## Additional Generalized Future Land Use Map Comments 6/8/18

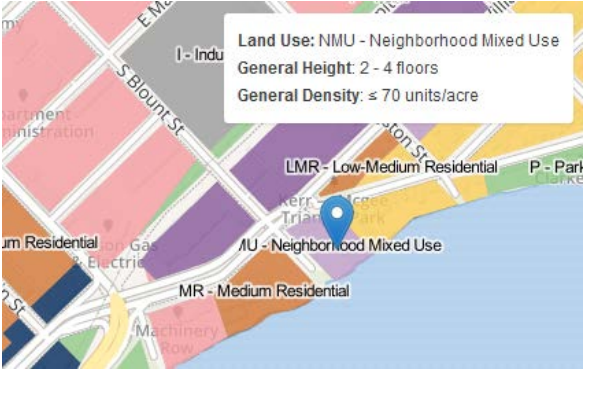
8	5/29 Krauskopf Message	Why was the Carey Ct. area changed from LR to LMR?	LMR is based on the current unit mix for the area (mix of single-family, duplex, and 3+ DUs). The message does not make a request to change the GFLU designation. See the discussion below for a location map and further analysis.	Maintain LMR.	N
9	5/29 sjkrausk Message (#1)	<p>Restrict buildings on the 2000 block of East Washington (on the N side) to two stories.</p> 	Staff interprets this as a request to change the area from LMR to LR. This area, along with the Options in Community Living apartments to the southwest and the E. Washington Ave. frontage to the northeast, were LDR in 2006. Staff reclassified the area with the addition of LMR as a category with this Plan update. The block bounded by Carey Ct., 2 <sup>nd</sup> St., E. Washington Ave., and 3 <sup>rd</sup> St., is made up of small-lot single family (generally 2,900-3,700 square foot lots), with three duplexes and one three-unit. This development is less intense than other LMR-designated areas to the southwest, southeast, and northeast, but the block is different than the exclusively single-family block to the northwest.	Maintain LMR.	Y
